Burlington Development Review Board

Development Review Board

Tuesday, November 18, 2025, 5:00 PM

Proposed
development
93-97 North St.
Burlington, VT 05401

GROUND LEVEL

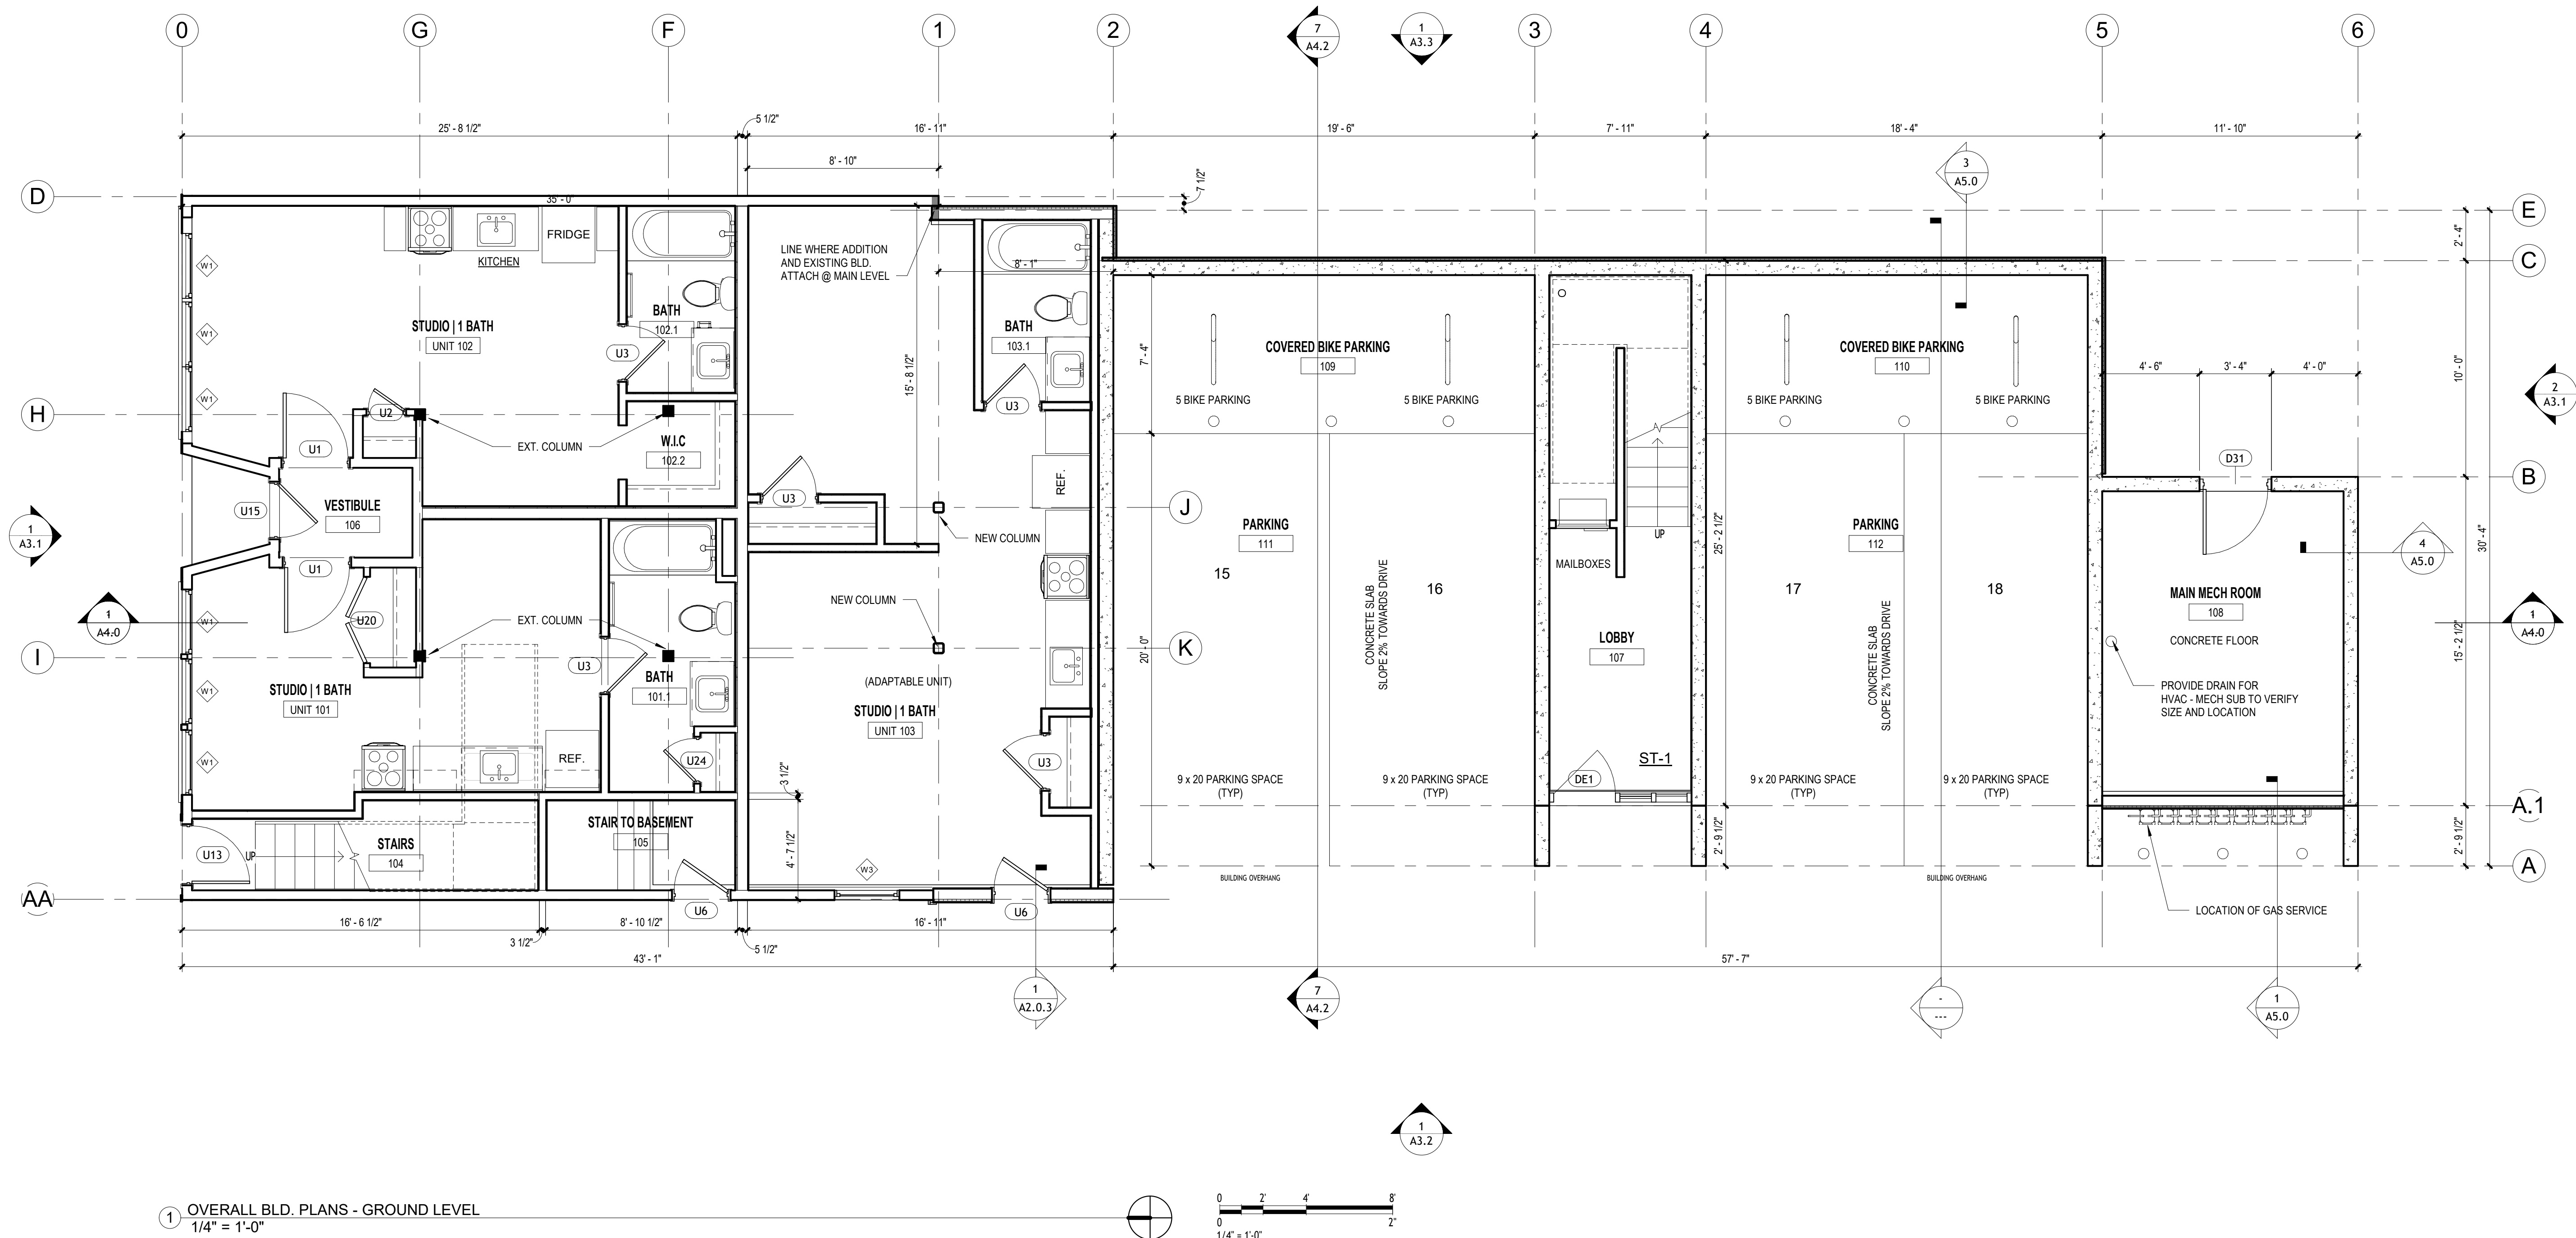
No ground mounted mechanical equipment is depicted in the project plans. Project plans depict a trash and recycling enclosure at the south end of the parking area. Enclosure details are needed. Mailbox locations are depicted in the revised ground-level floor plan. **(Affirmative finding as conditioned)**

Revised project plans depict covered long term bike parking spaces within the garage. The number of long term bike parking spaces required is determined by the number of bedrooms (1 per 2 bedrooms). The project includes a total of 20 bedrooms; therefore, 10 long term bike parking spaces are needed. The plans depict 20 long term bike parking spaces. The net new 14 dwelling units require at least 1 short term bike parking space. The revised project plans depict an outdoor bike rack with capacity for 5 spaces. **(Affirmative finding)**

CONDITION	SHEET
1. A. PROVIDE COMPLETE LANDSCAPING PLAN	SEE PLAN L.1
B. SHOW CURB STOPS	SEE PLAN L.1
C. CONFORMATION OF 5'-0" SETBACK	SEE PLAN L.1
D. DEPICT MAILBOX LOCATIONS	SEE PLAN A2.1 (GROUND LEVEL PLAN)
E. CORRECT F.A.R	SEE PLAN L.1 DATA BOX
F. BICYCLE PARKING	SEE PLAN L.1
	SEE PLAN A2.1
5. TRANSPORTATION DEMAND MANAGEMENT	SEE T.1

LANDSCAPING PLAN

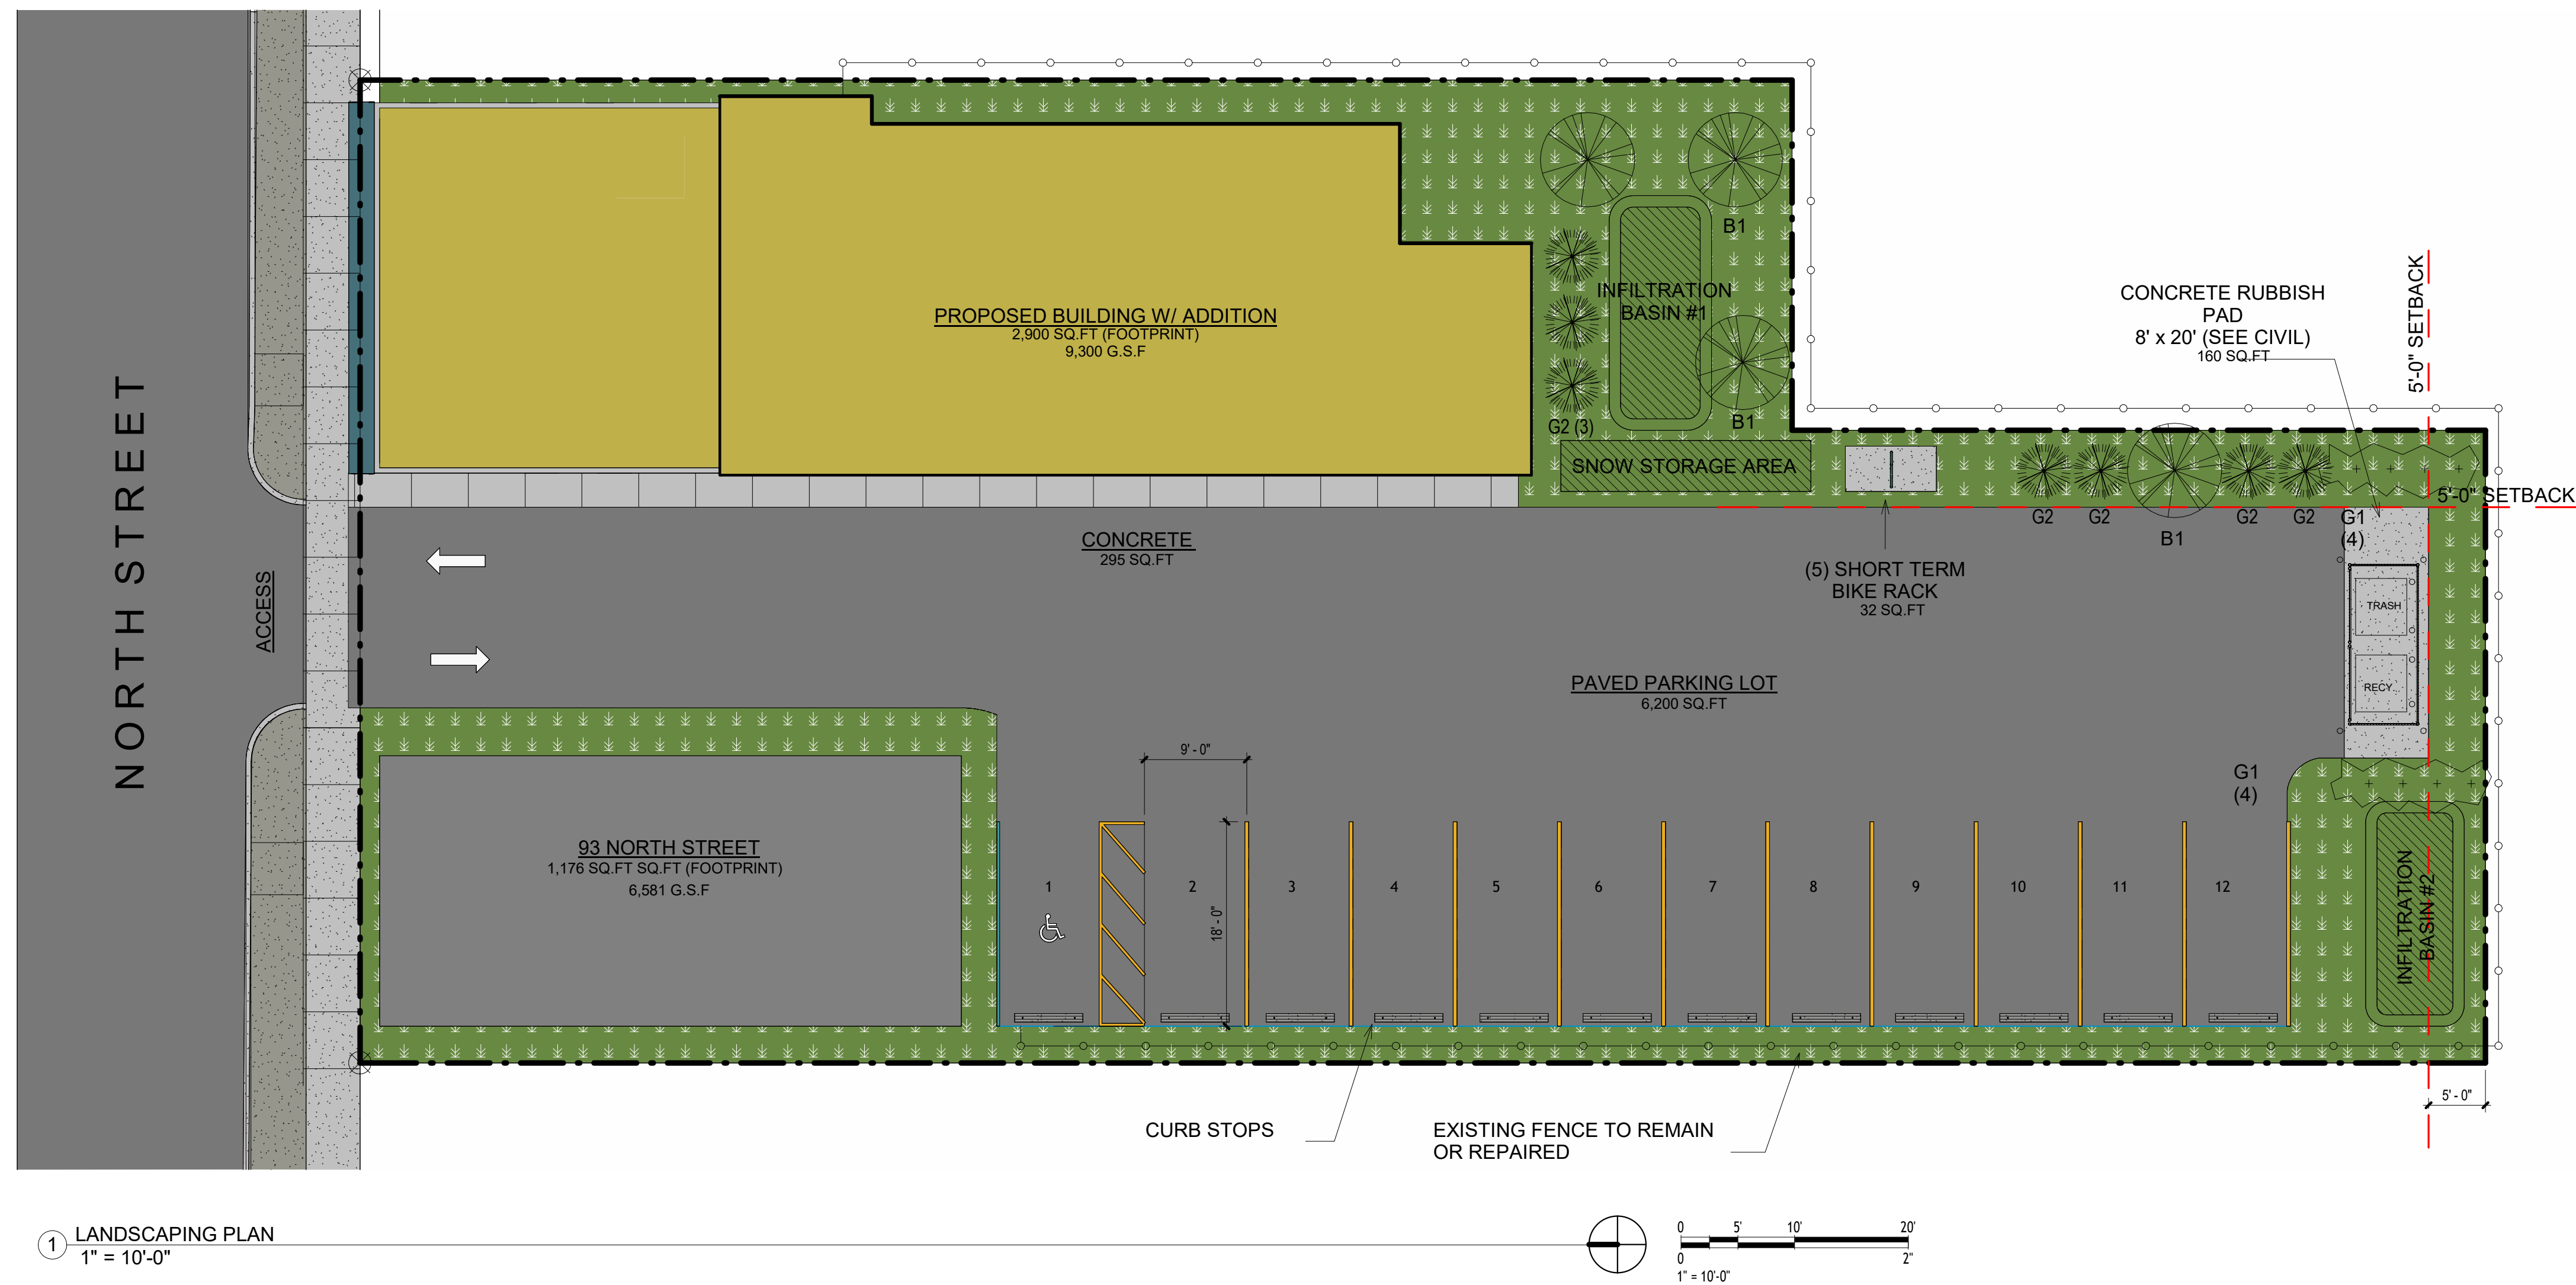
The revised project plans depict landscaping details, including several new trees and ornamental grasses. The numbers of proposed plantings does not line up with the number of corresponding icons on the plan. Five new maple trees are noted, but only four are depicted on the plans. Eight clumps of ornamental grasses are noted, but only seven are depicted on the plans. Correction is needed. The project plans contain two detention basins for stormwater. There is opportunity here to provide landscaping appropriate for rain gardens in these two basins. No new fencing is proposed, except that a stretch of existing fencing along the eastern side property line will be replaced in-kind. No retaining walls are proposed. **(Affirmative finding as conditioned)**

1. **Prior to release of the zoning permit**, revised project plans shall provide consistency in the number of proposed plantings, and consideration should be made for installation of hydrophitic vegetation in the stormwater basins. Revised project plans shall also include dumpster enclosure details. Both are subject to staff review and approval.

Replanting Plan for 276 Ethan Allen PKWY

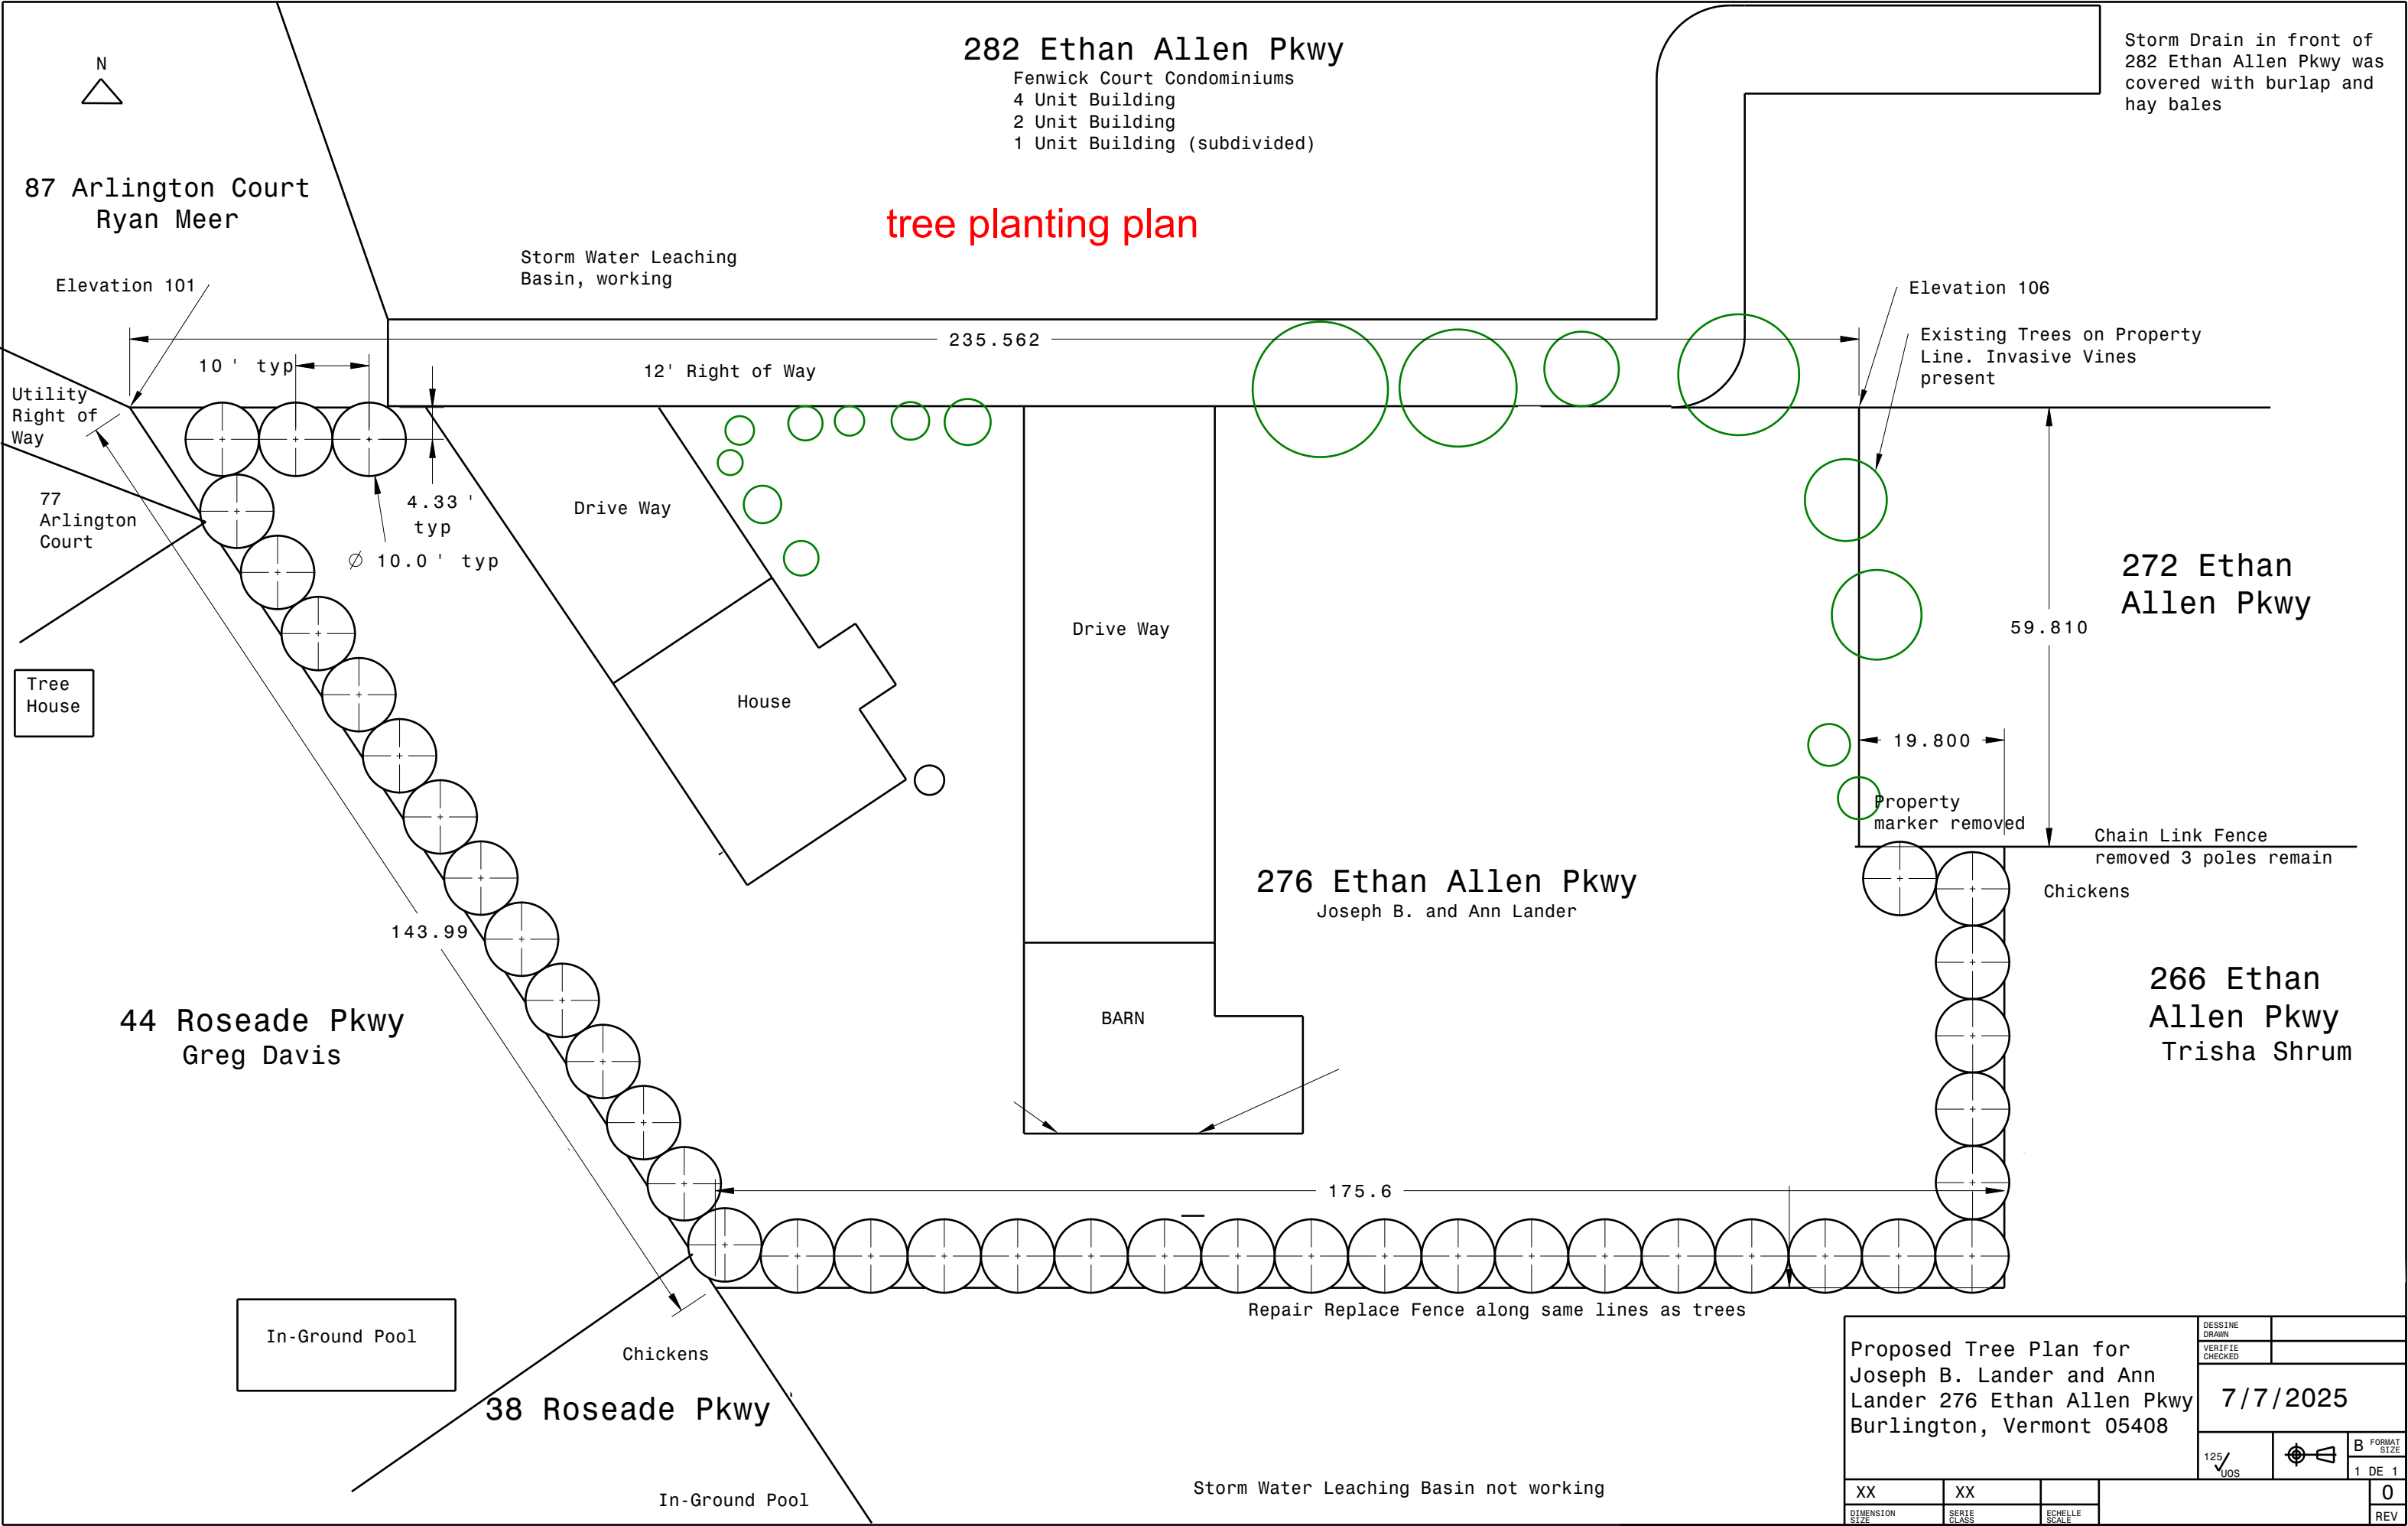
The appellants/applicants are seeking an extension into Spring of 2026 to install the plantings. Staff does not support the extension request. A complaint of the unpermitted tree cutting was received November 5, 2024. An after-the-fact application for the tree cutting was submitted December 3, 2024. That application was referred to DRB January 7, 2025 and was deferred by the Board to give the applicants time to come up with a tree planting plan. That application eventually timed out and was denied administratively June 9, 2025. The applicants appealed the denial to the Development Review Board. As noted above, the DRB upheld the appeal on August 5, 2025 and also required installation of the new trees by year's end. More than a year has lapsed since the original complaint was received.

Accordingly, pursuant to Standard Condition 2 of the August 7, 2025 Zoning Permit, the Landers seek an extension of the planting deadline. The Landers fully intend to install the trees, but due to the needs of the trees themselves and the significant financial outlay the plantings represent for the Landers, they wish to do so when the conditions are best for ensuring their trees' survival. As explained in the letter from Troy Lombard of DJ's Tree service, a certified arborist, included as Attachment B, the trees require substantial quantities of water when planted and should not be planted at a time when extended freezing temperatures are expected. Thus, planting the trees earlier this fall was not advisable due to the significant drought conditions experienced in Chittenden County and throughout Vermont. Planting now is not advisable due to the potential for frost and snow, which conditions could harm the trees health and longevity and ultimately cause them to die, which would not advance the purpose for the trees, to provide screening of the Landers property to and from the neighbors.

The Landers wish to reiterate that they are committed to installing the trees as proposed, and will complete the installation in the spring of 2026. For these reasons, the Landers seek approval for an extension of the planting deadline by six months.
